Dated: 08.07.2026

Corrigendum # 2

Name of the Work: - “Construction of Diversion Tunnels, Cofferdams, Main Dam including HM Works of Diversion Tunnels, approach roads and Bridges of Kamala H.E. Project (1720MW), Kamle district, Arunachal Pradesh (LOT-1)”

Tender ID.: 2026_NHPC_899454_1

7.0 DETAILS ABOUT IDENTIFIED DUMPING AREA:

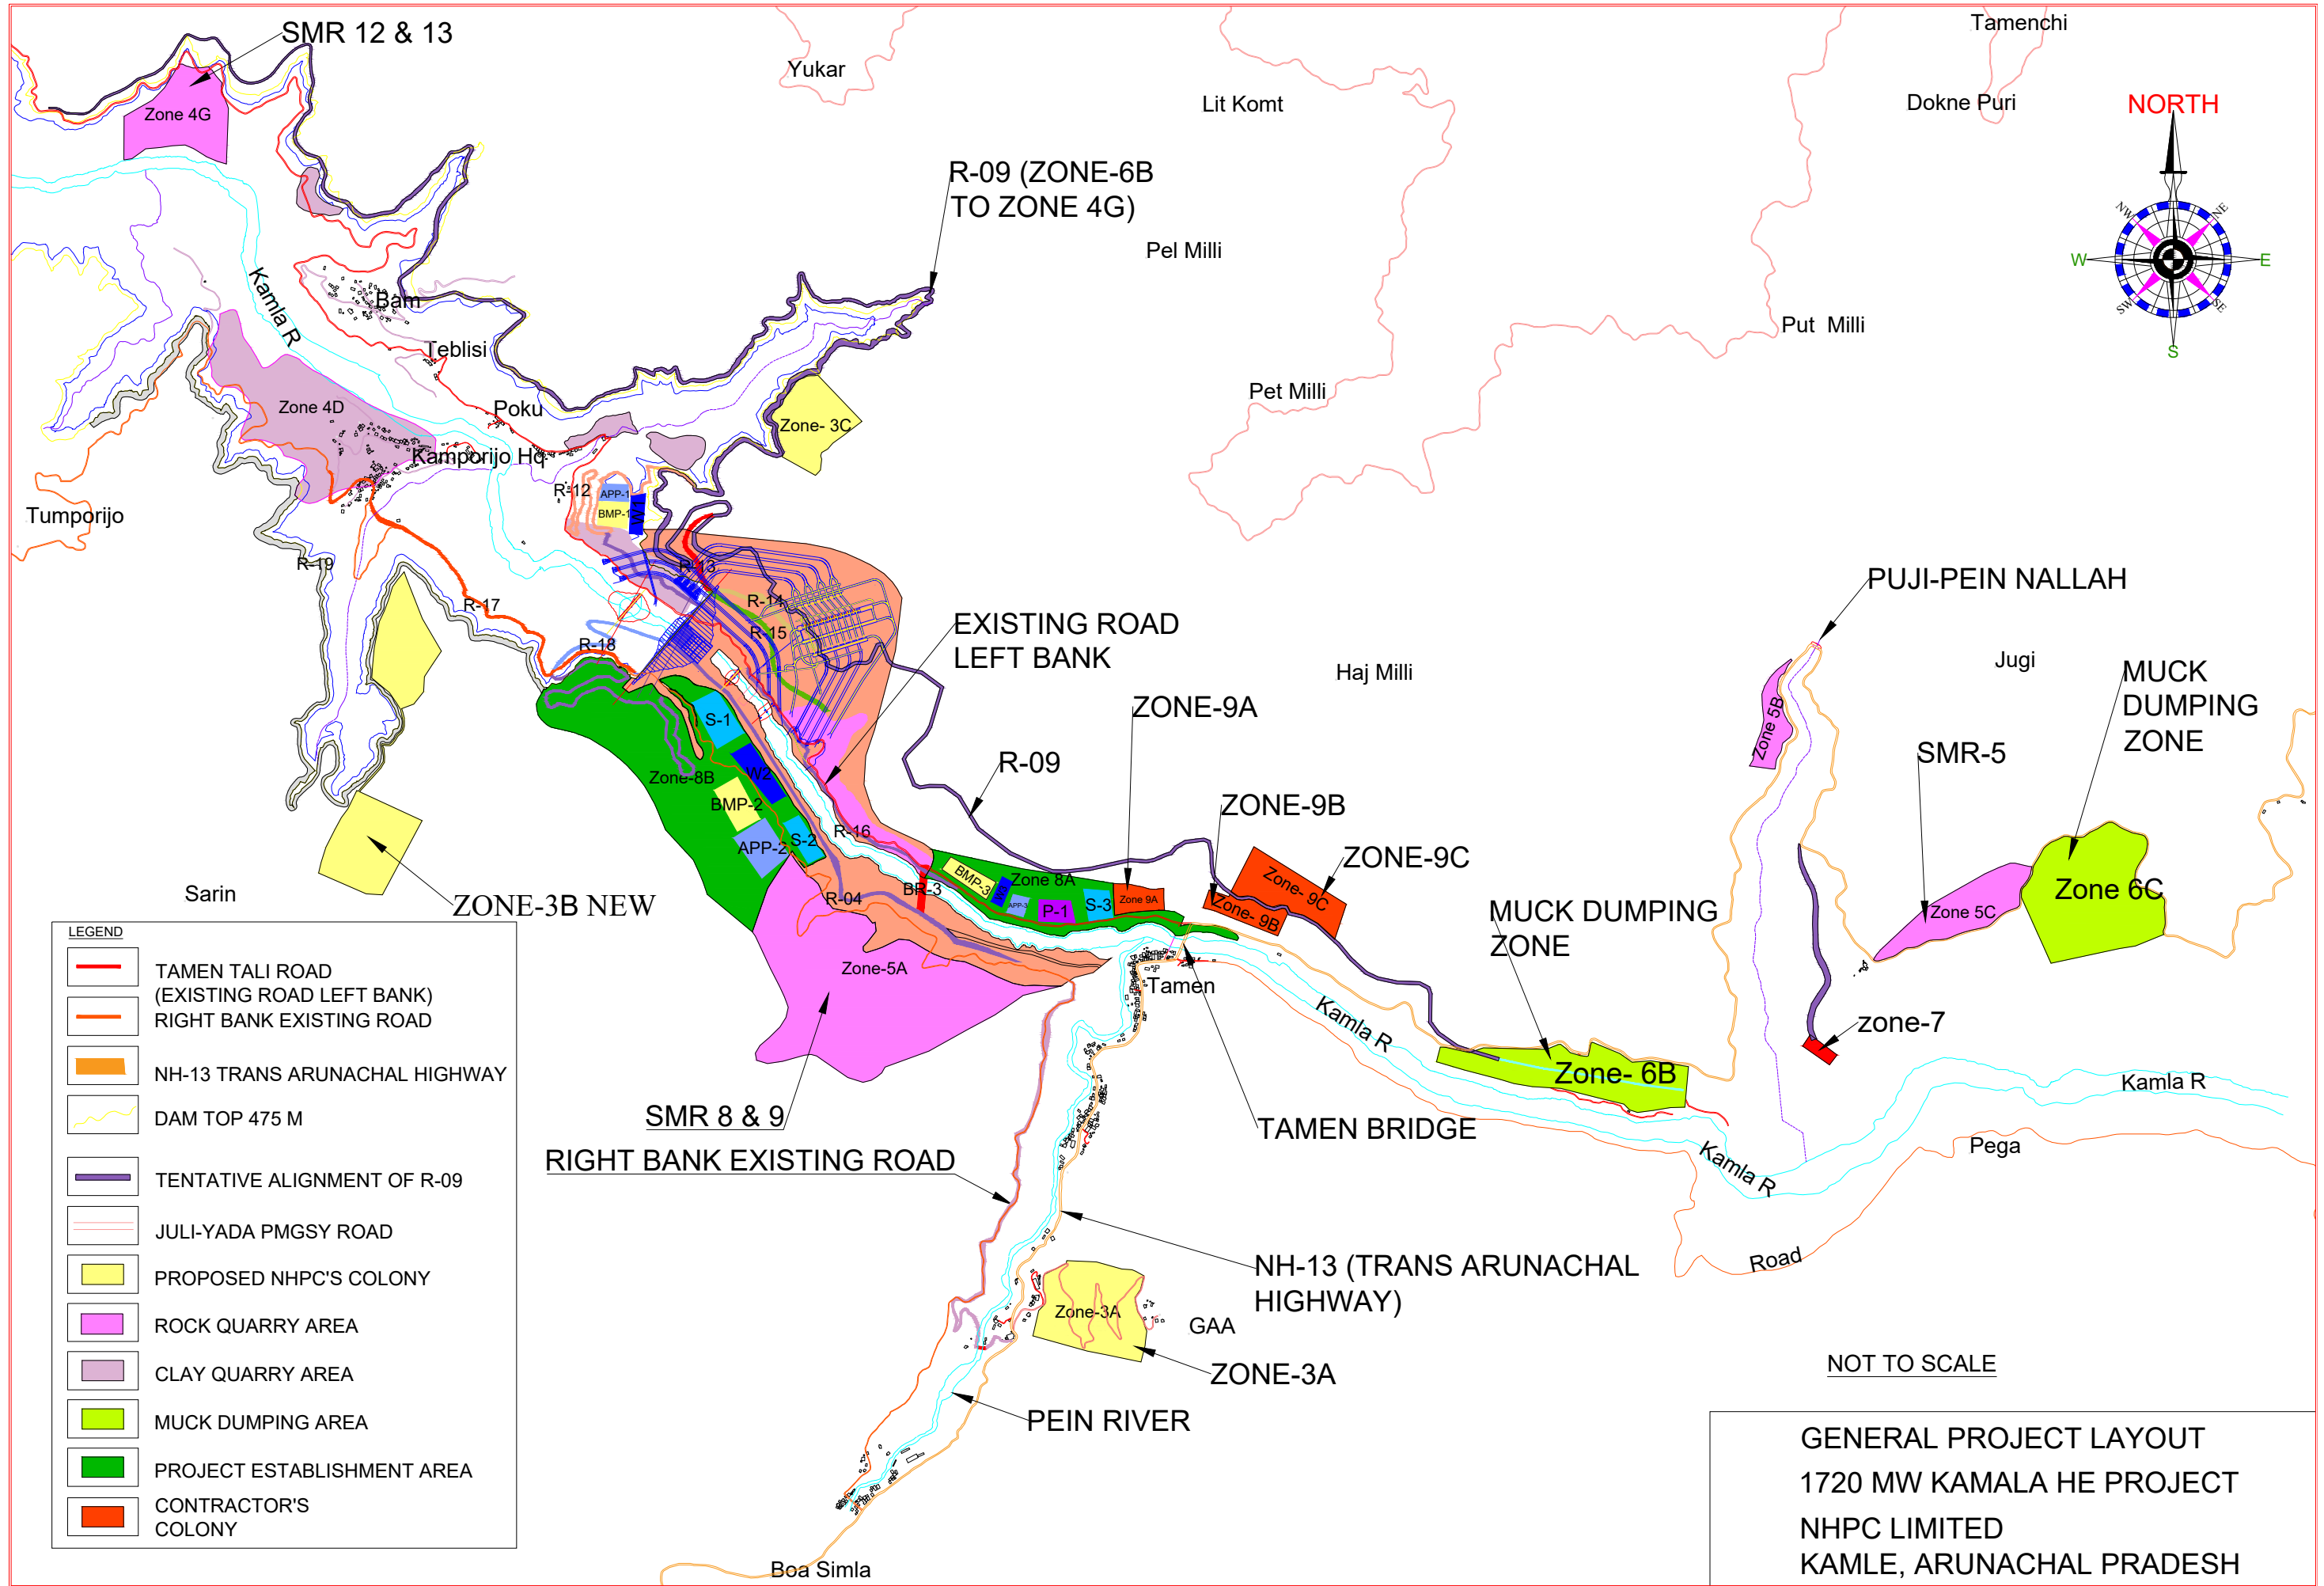
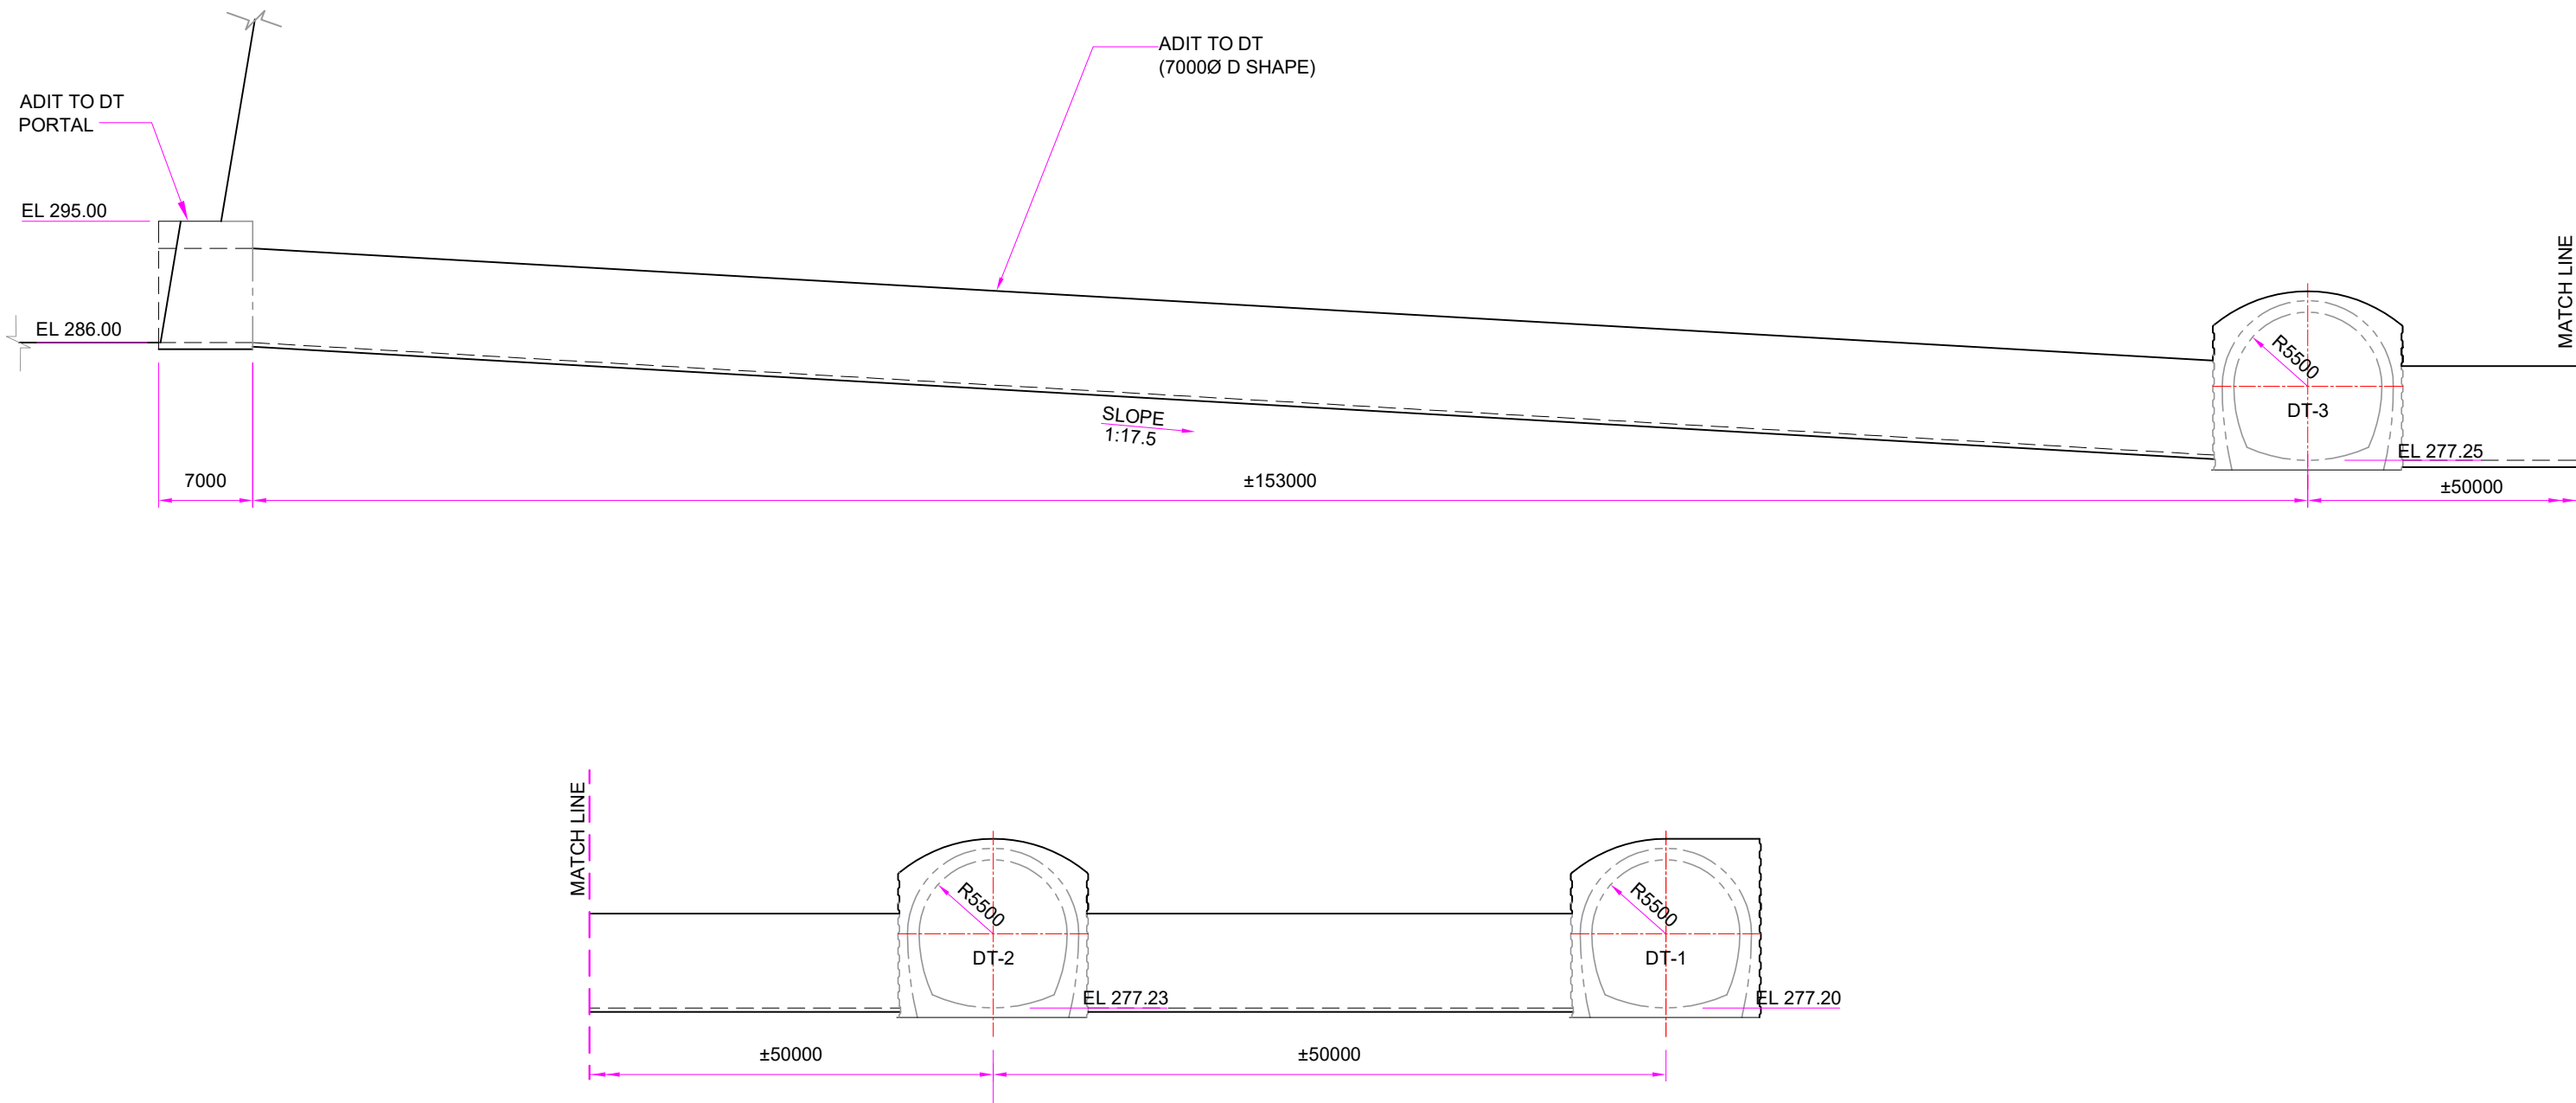
4.	Vol-1 Sec.1, IFB, Cl. 4.0 (3), Page No. 44 (Revised) Attached as Annexure -A	For disposal of muck, appropriate swelling shall be used for construction. There are four designated disposal locations identified (Zones 6A-1, 6A-2, 6B and 6C) on either side of the Kamala River. The list of dumping sites proposed are listed below: <table><tr><th>Sl. No .</th><th>Dumpin g Yard</th><th>Plan Area (Ha)</th><th>Averag e Distanc e from Dam area (Km)</th><th>Structur e</th></tr><tr><td rowspan="2">1</td><td>Zone 6A-1</td><td>4.00</td><td>4.5</td><td rowspan="2">For Lot-1 Works</td></tr><tr><td>Zone 6A-2</td><td>4.40</td><td>4.0</td></tr><tr><td>2</td><td>Zone 6B</td><td>22.00</td><td>5.5</td><td>For Lot-1 & Lot-2 Works</td></tr><tr><td>3</td><td>Zone 6C</td><td>32.60</td><td>12.0</td><td>Balance quantity of Lot 1 & Lot-2 Works</td></tr></table> Dumping sites Zones 6A-1, 6A-2 are designated for use of LOT-1 Contractor and Dumping sites Zones 6B & Zone 6C are designated for use of LOT-1 & Lot-2 Contractor (50% area for each Lot).	Sl. No .	Dumpin g Yard	Plan Area (Ha)	Averag e Distanc e from Dam area (Km)	Structur e	1	Zone 6A-1	4.00	4.5	For Lot-1 Works	Zone 6A-2	4.40	4.0	2	Zone 6B	22.00	5.5	For Lot-1 & Lot-2 Works	3	Zone 6C	32.60	12.0	Balance quantity of Lot 1 & Lot-2 Works	For disposal of muck, appropriate swelling ... used for construction. There were four designated disposal locations identified (Zones 6A-1, 6A-2, 6B and 6C) on either side of the Kamala River. Now as per the revised proposal there are only two dumping sites i.e. Zone 6B and 6C. The details of dumping sites proposed are listed below: <table><tr><th>Sl. No .</th><th>Dumpin g Yard</th><th>Plan Area (Ha)</th><th>Averag e Distanc e from Dam area (Km)</th><th>Structur e</th></tr><tr><td>1</td><td>Zone 6B</td><td>22.00</td><td>5.5</td><td>For Lot-1 & Lot-2 Works</td></tr><tr><td>2</td><td>Zone 6C</td><td>32.60</td><td>12.0</td><td>Balance quantity of Lot 1 & Lot-2 Works</td></tr></table> The bidder will have to dispose of the excavated material at the dumping sites of Zone 6B and Zone 6C, utilizing 50% of the allotted area, as the dumping sites of Zone 6B and Zone 6C are earmarked for use by the contractors of Lot-1 and Lot-2 (50% area for each lot).	Sl. No .	Dumpin g Yard	Plan Area (Ha)	Averag e Distanc e from Dam area (Km)	Structur e	1	Zone 6B	22.00	5.5	For Lot-1 & Lot-2 Works	2	Zone 6C	32.60	12.0	Balance quantity of Lot 1 & Lot-2 Works

Sl. No .	Dumpin g Yard	Plan Area (Ha)	Averag e Distanc e from Dam area (Km)	Structur e																																					
1	Zone 6A-1	4.00	4.5	For Lot-1 Works																																					
	Zone 6A-2	4.40	4.0																																						
2	Zone 6B	22.00	5.5	For Lot-1 & Lot-2 Works																																					
3	Zone 6C	32.60	12.0	Balance quantity of Lot 1 & Lot-2 Works																																					
Sl. No .	Dumpin g Yard	Plan Area (Ha)	Averag e Distanc e from Dam area (Km)	Structur e																																					
1	Zone 6B	22.00	5.5	For Lot-1 & Lot-2 Works																																					
2	Zone 6C	32.60	12.0	Balance quantity of Lot 1 & Lot-2 Works

For disposal of muck, appropriate swelling factor has been considered over and above the muck generated from rock excavation / underground excavation. However, the excavated material shall be tested for their suitability for use as construction material during the construction stage and the material suitable shall be used for construction. There were four designated disposal locations identified (Zones 6A-1, 6A-2, 6B and 6C) on either side of the Kamala River. Now as per the revised proposal there are only two dumping sites i.e. Zone 6B and 6C. The details of dumping sites proposed are listed below:

Sl. No.	Dumping Yard	Plan Area (Ha)	Average Distance from Dam area (Km)	Structure
1.	Zone 6B	22.00	5.5	For Lot-1 & Lot-2 Works
2.	Zone 6C	32.60	12.0	Balance quantity of Lot-1 & Lot-2 Works

The bidder will have to dispose of the excavated material at the dumping sites of Zone 6B and Zone 6C, utilizing 50% of the allotted area, as the dumping sites of Zone 6B and Zone 6C are earmarked for use by the contractors of Lot-1 and Lot-2 (50% area for each lot).

ADIT TO DIVERSION TUNNEL
SETTING OUT
L-SECTION

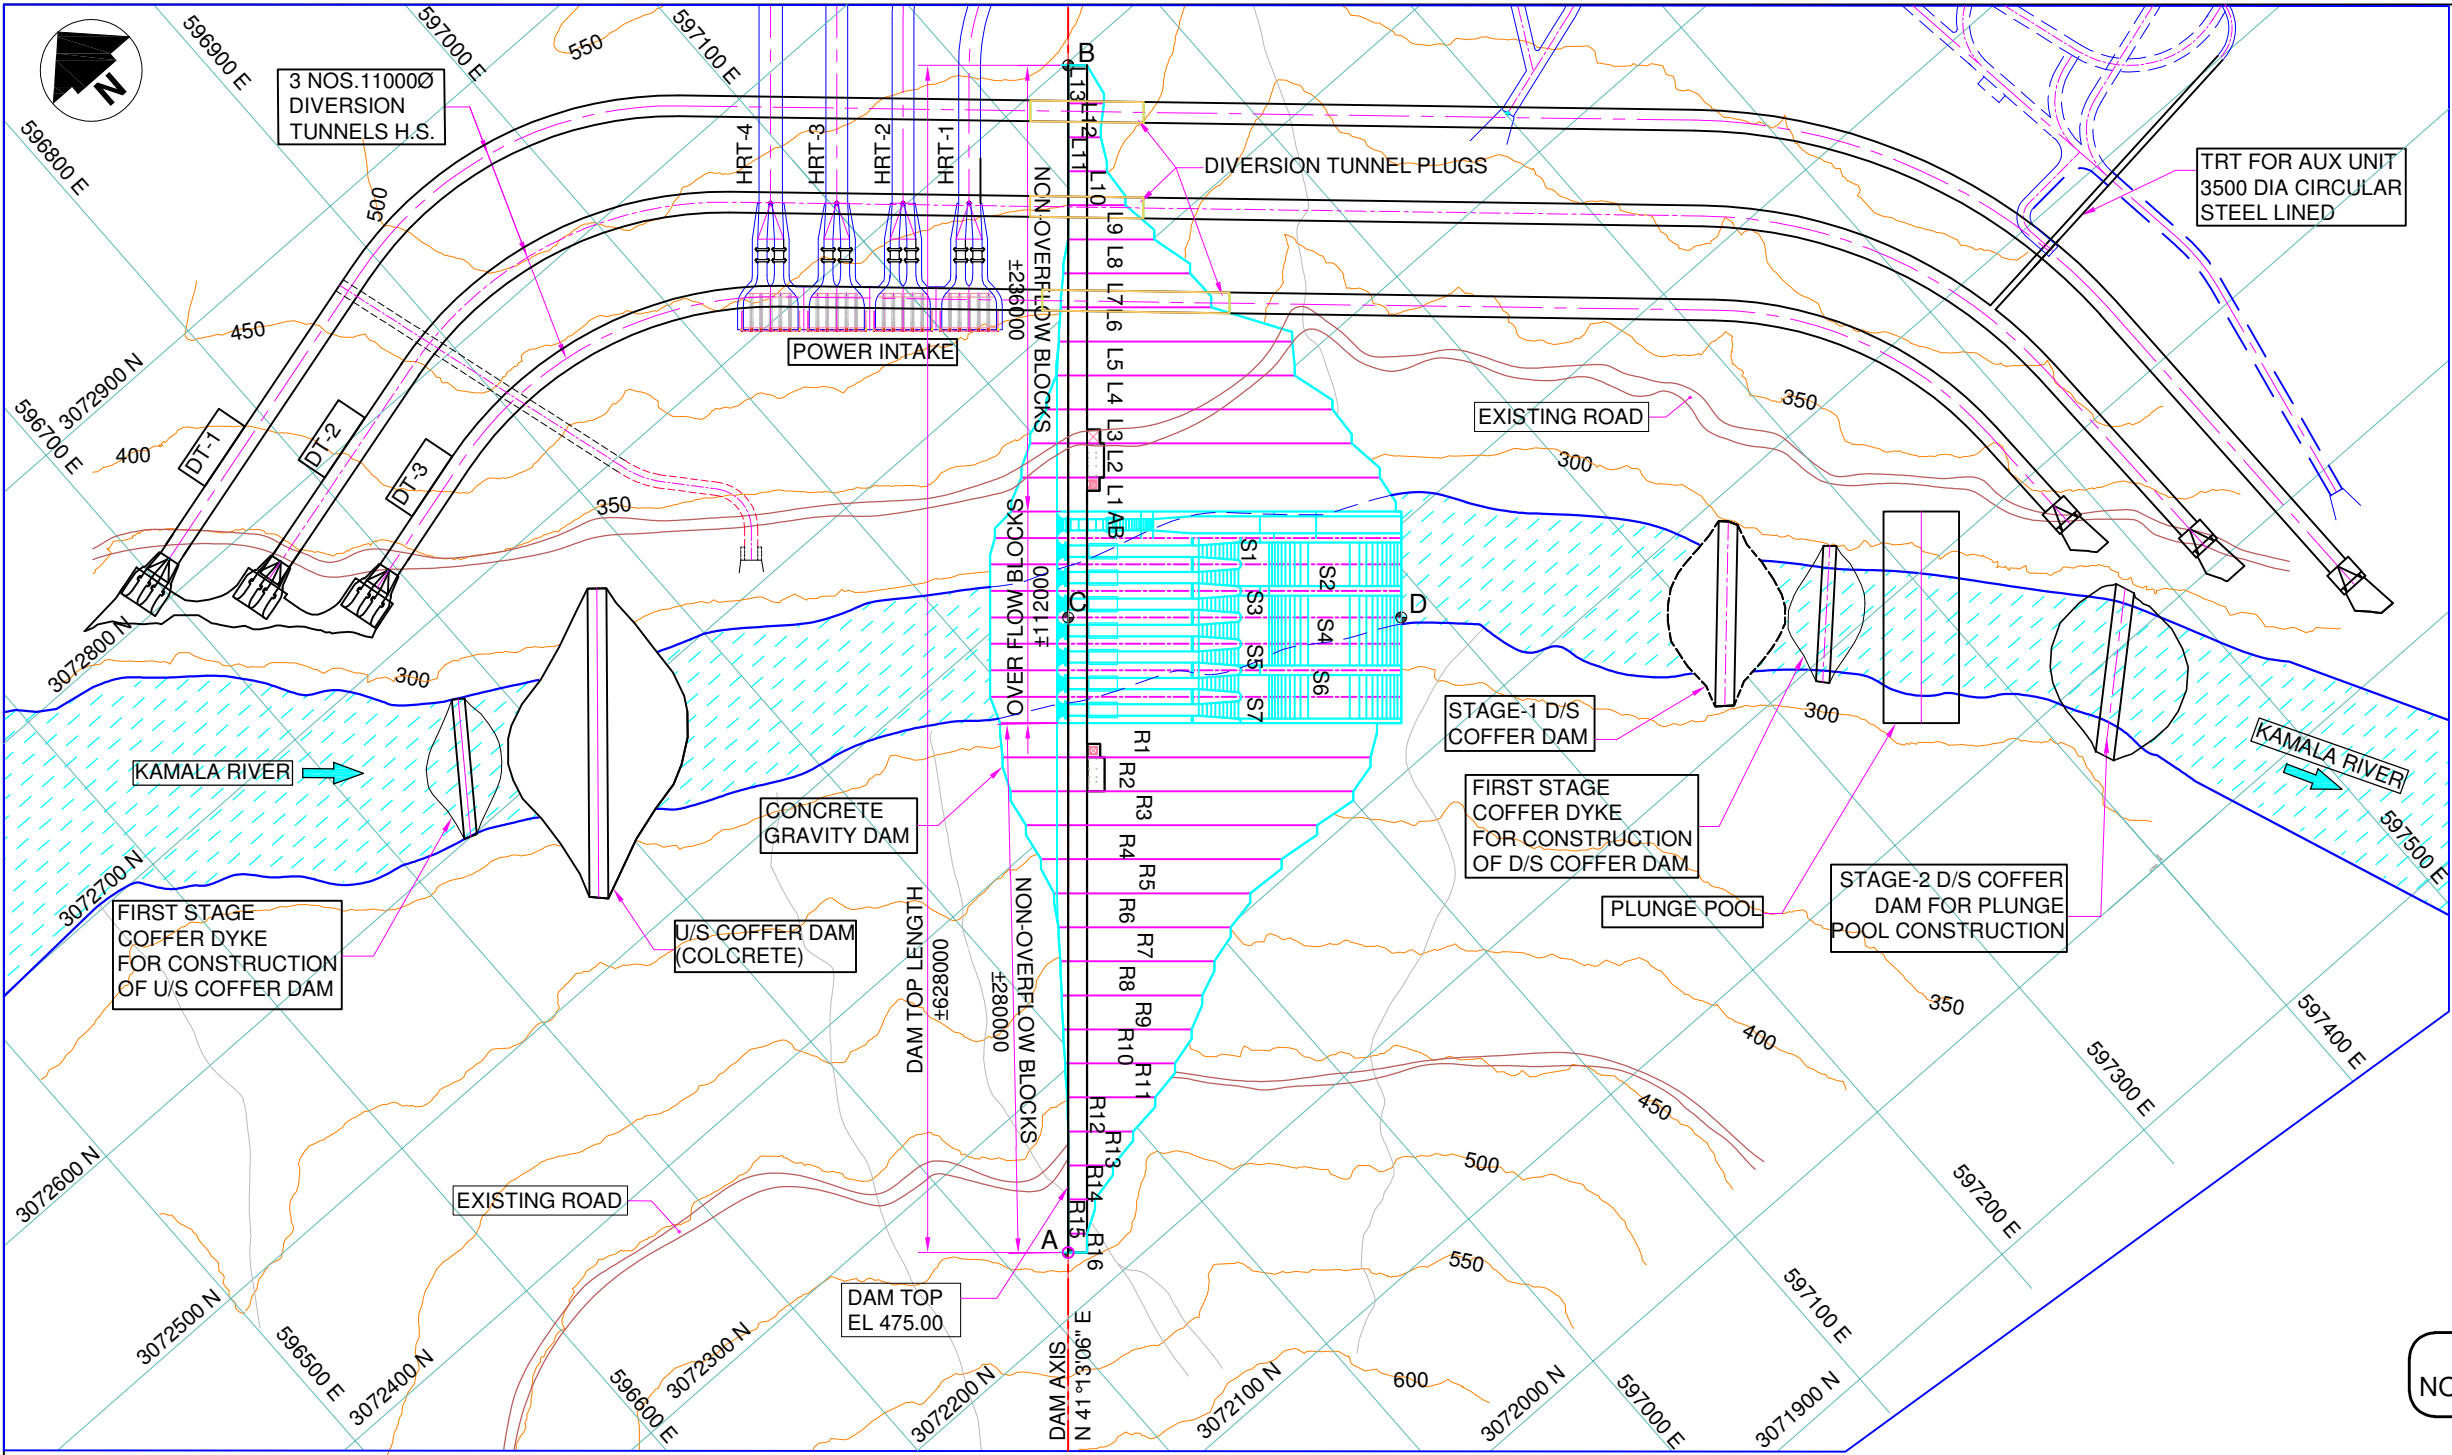
13.	Tender Drawings (New Added)	Adit To Diversion Tunnel Setting Out L-Section	Drawing showing Adit To Diversion Tunnel Setting Out L-Section is enclosed as Annexure-C .
